# HISTORIC AND DESIGN REVIEW COMMISSION

August 07, 2019

**HDRC CASE NO:** 2019-431  
**ADDRESS:** 2026 W GRAMERCY PLACE  
**LEGAL DESCRIPTION:** NCB 1933 BLK 31 LOT 22  
**ZONING:** R-6,H  
**CITY COUNCIL DIST.:** 7  
**DISTRICT:** Monticello Park Historic District  
**TYPE OF WORK:** Window replacement, fenestration modifications, exterior modifications  
**APPLICATION RECEIVED:** July 22, 2019  
**60-DAY REVIEW:** September 20, 2019  
**CASE MANAGER:** Stephanie Phillips  
**REQUEST:**

1 SITE PLAN  
SCALE: 1/8"=1'-0"

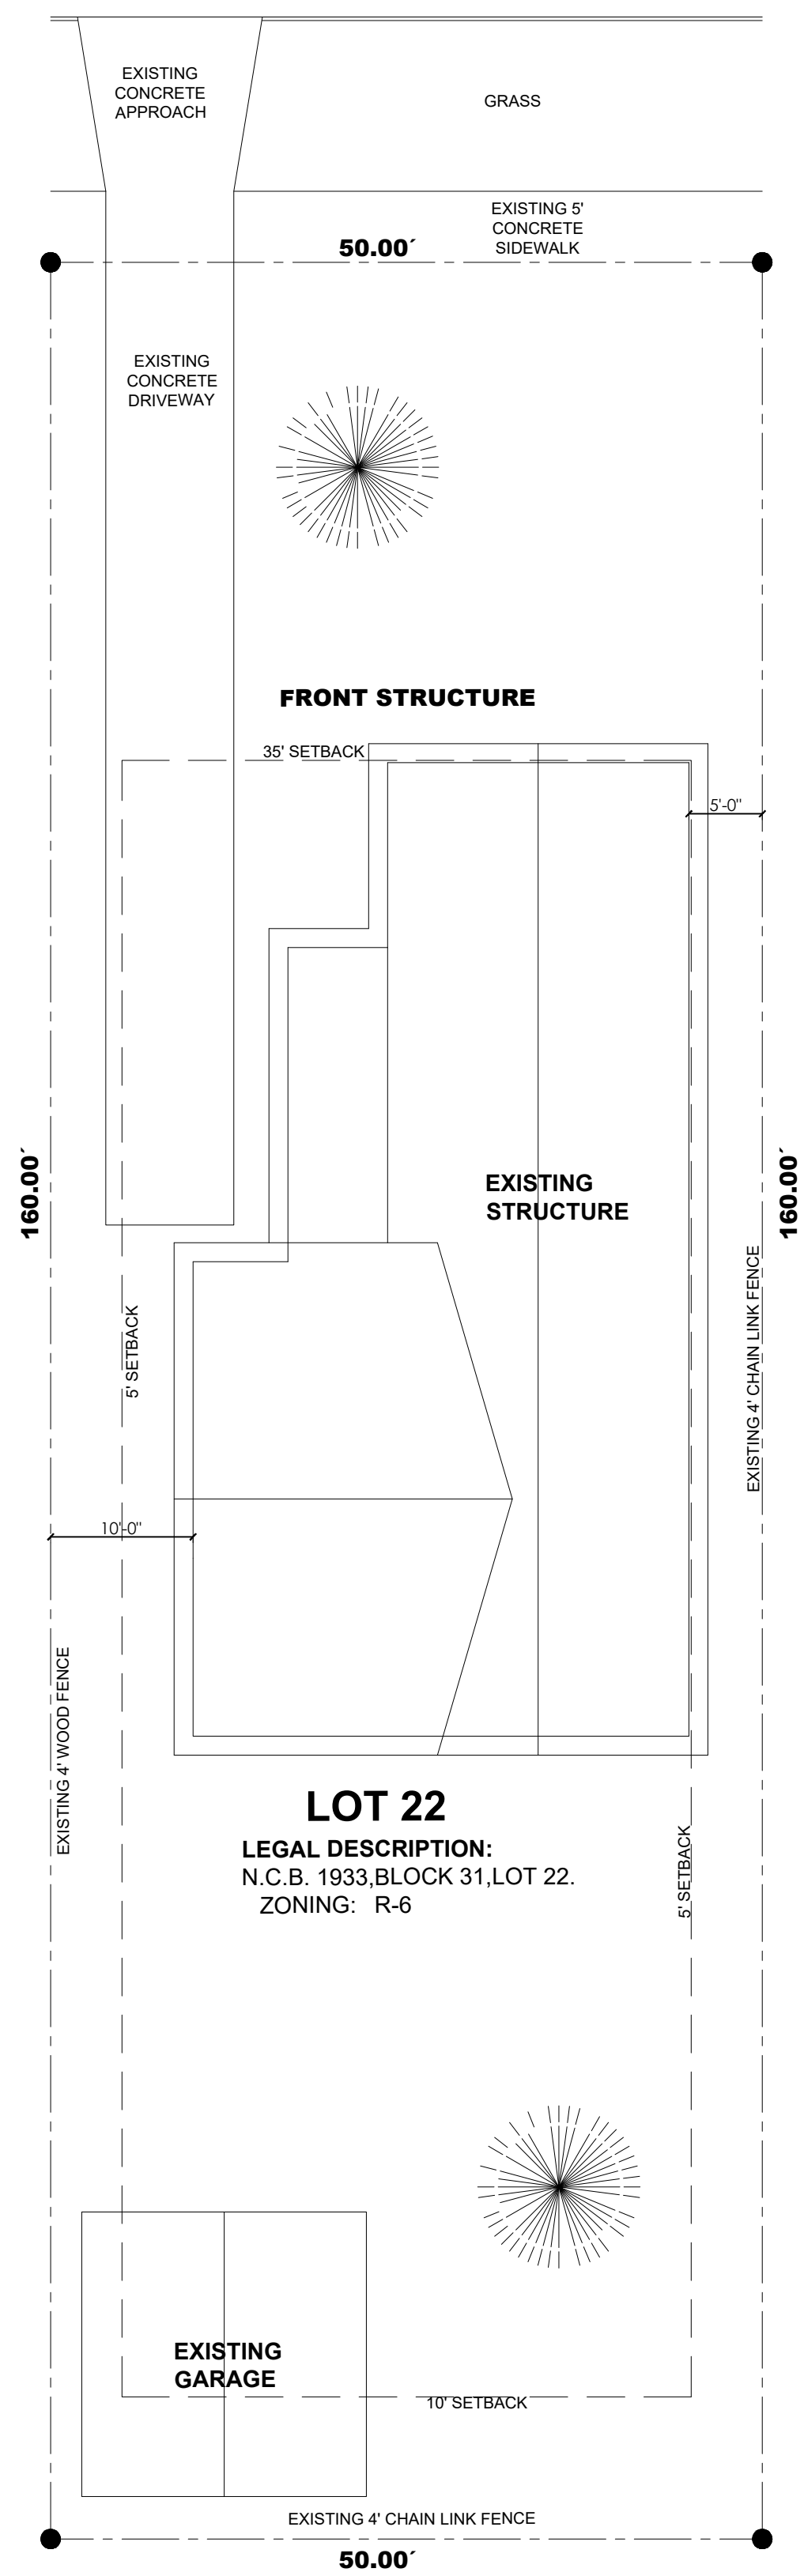
- d. **WINDOW ENCLOSURE** – The applicant has requested to enclose two windows on the property. Both are located on the rear elevation and are screened from the public right-of-way. Based on the modifications that have occurred on this property, staff finds that the enclosure of these windows is acceptable.

- e. **DOOR ENCLOSURE** – The applicant has requested to enclose one of two front doors. The door to be enclosed is facing W Gramercy Pl and is directly viewable from the public right-of-way. According to the Guidelines,

existing doors should be preserved. Staff finds that this door location is likely original due to the porch design and configuration and finds its removal inconsistent with the Guidelines.

- f. **PORCH MODIFICATIONS** – The applicant has proposed to replace two non-original wrought iron front porch columns with two new simple wood post columns measuring 6x6” square. According to the Historic Design Guidelines, porches and their related elements, such as ceilings, floors, and columns, should be replaced in-kind when such features are deteriorated beyond repair. When in-kind replacement is not feasible, the design should be compatible in scale, massing, and detail while materials should match in color, texture, dimensions, and finish. The proposed porch columns are generally proportionate with the size of the porch footprint and are common on Minimal Traditional structures.

Item 2, Staff recommends approval of the window opening enclosure based on finding d.

Item 3, Staff does not recommend approval of the front door enclosure based on finding e.

Item 4, Staff recommends approval of the front porch column replacement based on finding f with the following stipulation:

- i. That the wood columns be six inch (6”) square with capital and base trim, and feature chamfered corners.
